**New Albany Architectural Review Board  
August 8, 2022 Minutes**

**ARB-84-2022 Certificate of Appropriateness**

**Certificate of Appropriateness for a new building additional 14 South High Street (PID: 222-000001).**

#### 14 SOUTH HIGH STREET BUILDING ADDITION CERTIFICATE OF APPROPRIATENESS

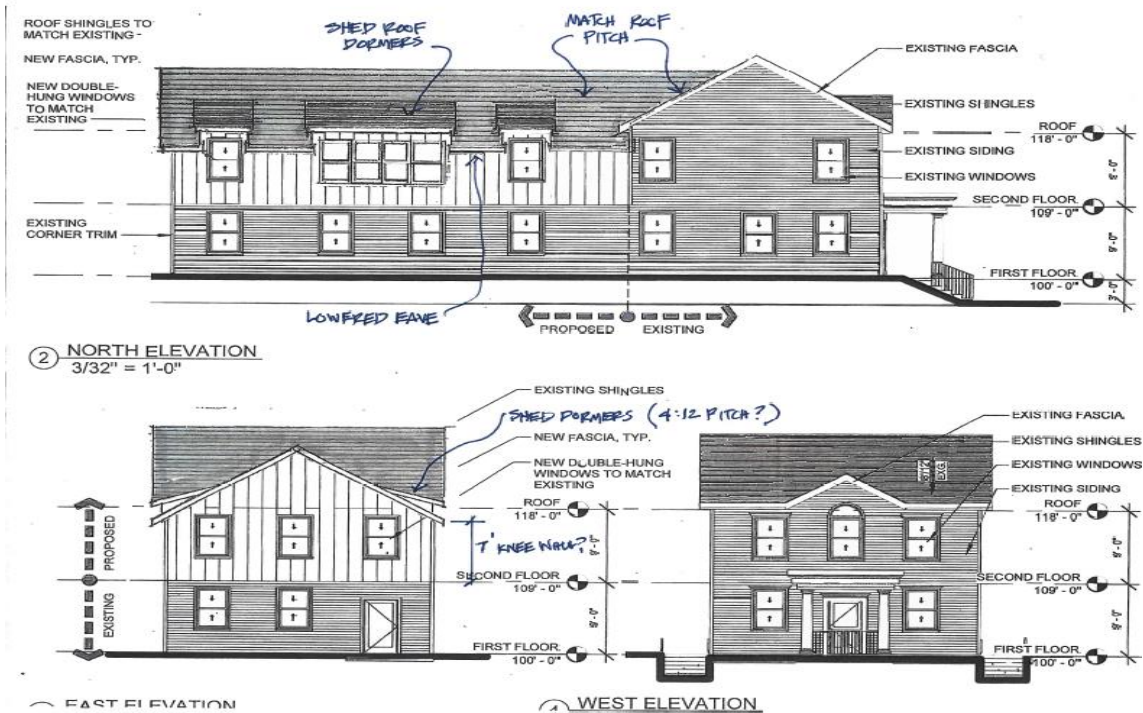
- The city architect has reviewed the application and comments that since the addition is a full two-story height structure, it doesn’t feel as if the renovation relates to the existing design as much as it should. The city architect recommends the following revisions:

- The visual break between the existing portion and new addition needs to happen at the eave.
- The roof pitch of the existing structure and new addition are to match.
- Shed roof dormers are to be added with a 4:12 pitch.
- The addition is to have a 7' tall knee wall between the existing one-story portion of the structure and the new roof for the addition.
- Staff recommends a condition of approval that all comments from the city architect are satisfied, subject to staff approval. The city architect created the following sketch to indicate what additional detailing he recommends:

- The city architect’s rendering above shows how they recommend to visually separate the existing and new eave lines, in order to maintain a hierarchy of the original main building shape. This rendering, along with the city architect’s comments, were provided to the applicant. The applicant responded by stating the property owner agrees to the revisions proposed by the city architect and they intend to provide updated renderings at the board meeting.

1. The applicant will replace the existing horizontal siding with hardie plank material at the City Architect's direction;
2. The elevation of the roof line of the rear addition will be updated to show a 12x12 roof pitch to match the existing original structure;

1. That the applicant must revise the design and drawings per the city architect's comments and the rendering provided, subject to staff approval.
2. The existing horizontal vinyl siding be replaced with horizontal Hardie board material.
